T.E.D.S. Exception for the Site Plan of Van Gundy's Recycle Center/Salvage Yard

Re: Design Exception #DE6-13, 14, 15, 16 – Van Gundy's Proposed site on 4th Ave.

DESIGN EXCEPTION #DE 6-13, 14,15 & 16

TITLE:	EXHIBIT "A"	SCALE:	N.T.S.	DATE:	04/04/06	DRAWN BY:	GAP	CAD I.D.#:	Gundy-Site.dwg
						CKD BY:	RWJII	PROJECT#:	F06-026

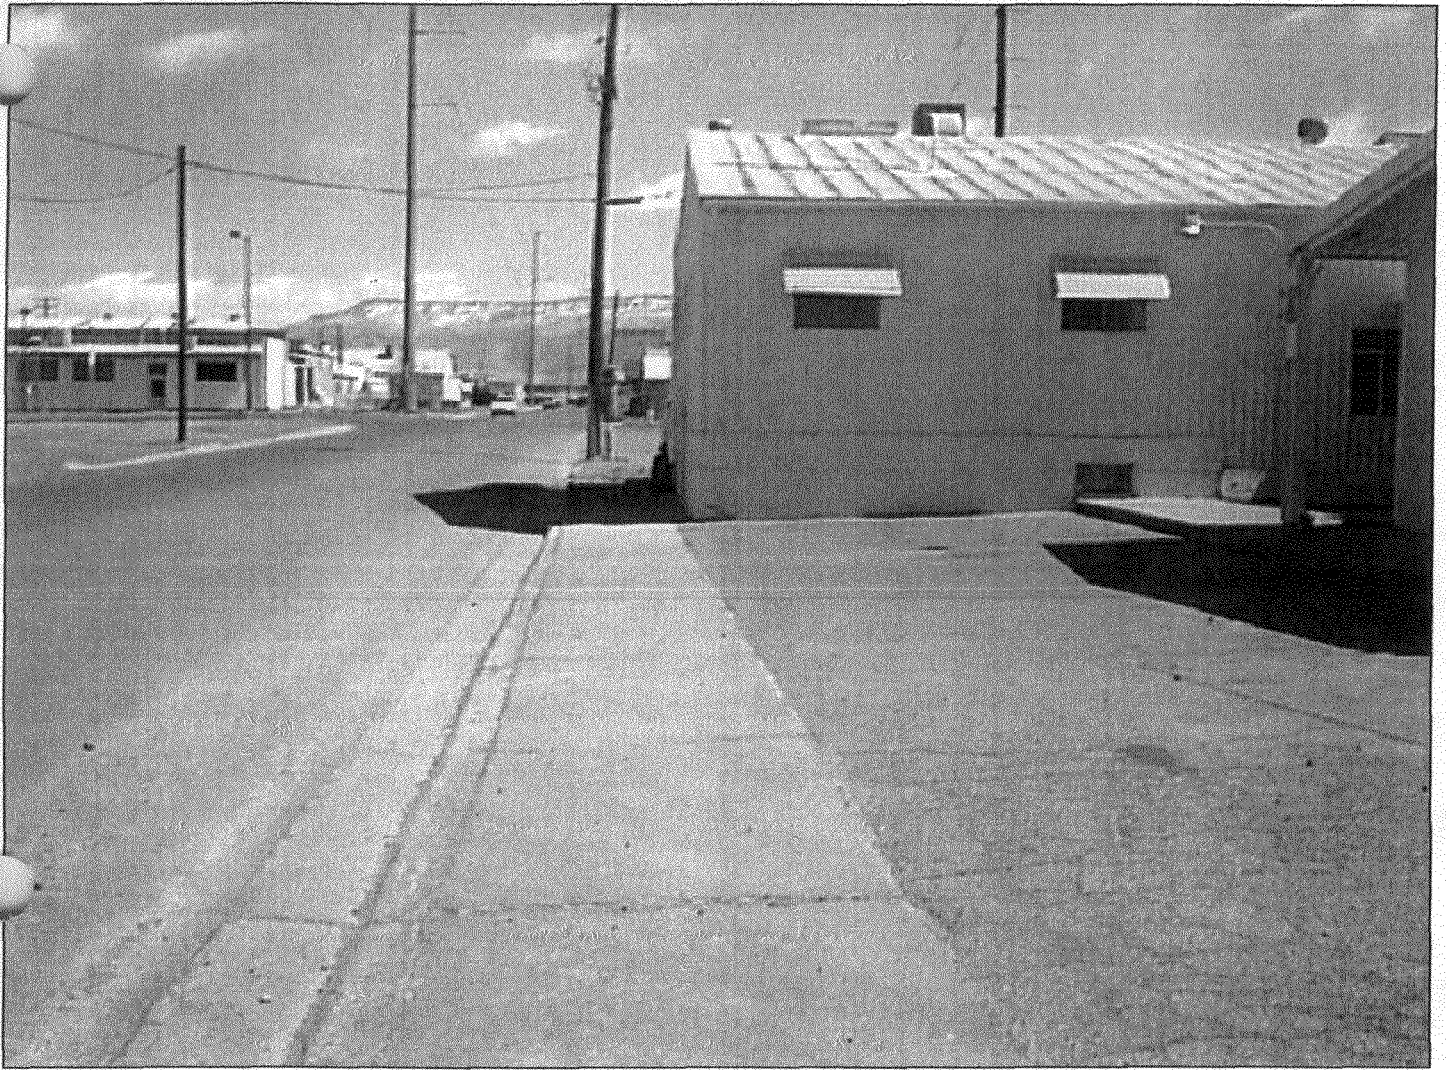
The Site Plan submitted to Community Development does not meet the TEDS standards in regards to providing a 14 Foot Multi Purpose Easement as shown on an Industrial Street Section (attached). As mentioned earlier, this site is approximately 20 percent smaller than the previous site and has more site constraints with the existing buildings and the triangular shape of the new lot. Quite simply, Van Gundy's needs as much room on the site for storage as possible. Additionally, the building in the northeast corner of the Sterling Site is approximately 6 foot from the existing street curb or 1 foot from the property line. A photo is attached as Exhibit A.

LOOKING EAST- EXISTING BUILDING
APPROXIMATLY 6' FROM BACK OF CURB

TITLE: EXHIBIT "B"

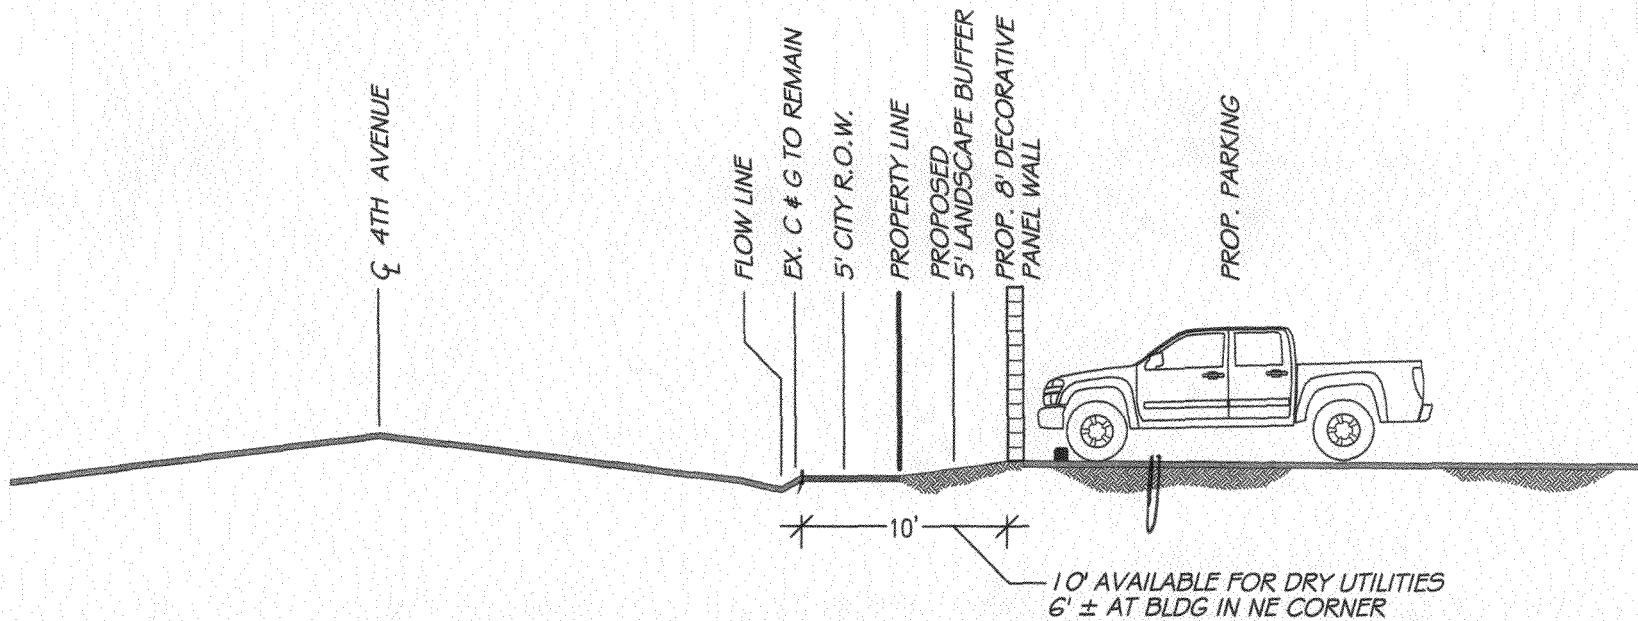
As part of the Conditional Use Permit (CUP), the City has required installation of an 8-foot high screening wall along 4th Avenue and 50 feet along each side from 4th avenue. Van Gundy's proposes to place the screening wall 5 feet from the property line to allow for additional storage and parking. Currently there is approximately 5 feet behind the existing curb to the property line. With the proposed wall placed 5 feet from the property line, this allows a total of 10 feet behind the curb for utilities. The exception to this is the location of the existing building in the northeast corner of the site. As discussed earlier, this building is approximately 6 feet from the street curb and the width is approximately 50 feet wide. Utilities would need to be placed in the 6-foot section between the building and the street curb. A sketch is attached as Exhibit B.

- Reduce to 14-foot multipurpose easement along 4th Avenue to 5 feet
- Eliminate the 14 foot multi purpose easement along 4th Avenue in front of the existing building (This would be for approximately 50 feet and utilities can be placed in the 6 foot section between the building and street curb)

- DE#13 – Approved
- DE#14 – Denied
- DE#15 – Approved

TITLE:
EASEMENT REDUCTION EXHIBIT

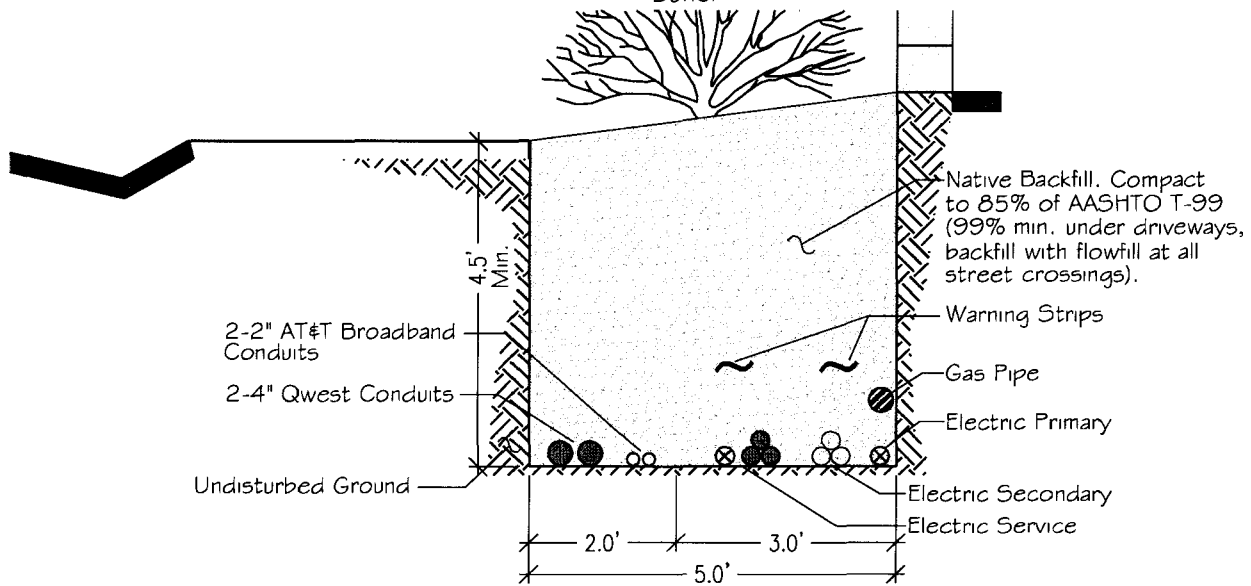
We understand that this easement is for “dry utilities”, Electrical, Cable, and Telephone. Including the area behind the curb, there will be approximately 10 feet for utilities. A sketch is included in Exhibit C. The 50-foot section in front of the building in the northeast corner of the site will have approximately 6 feet for “dry utilities”. We have checked with Xcel Energy, Bresnan Communications, and Qwest about this restriction. Bresnan has indicated approval (included in Exhibit C). We are awaiting comments from Xcel and Qwest.

- DE #13. Vortex Engineering requests the revision of Page ST-07, TEDS Chapter 5, to allow a five foot wide Multi-Purpose easement in lieu of the standard 14' easement. The Utility Coordinating Committee has reviewed this request and has provided a letter of support for this request.
- DE # 14. Vortex Engineering requests TEDS standard 4.2.5.1 be revised to allow 30' of storage between the new scale Van Gundy will install south of the main entrance off 4th Street and the flowline in the adjacent roadway.
- DE # 15. Vortex Engineering requests TEDS standard 4.1 be revised to allow driveways into the site to be offset less than the required 50' from driveways on the opposite side of the street.
- DE # 16. Vortex Engineering requests TEDS standard 4.3.1 be revised to allow 4th Ave. to function as a circulatory roadway between the scale and the storage yard.
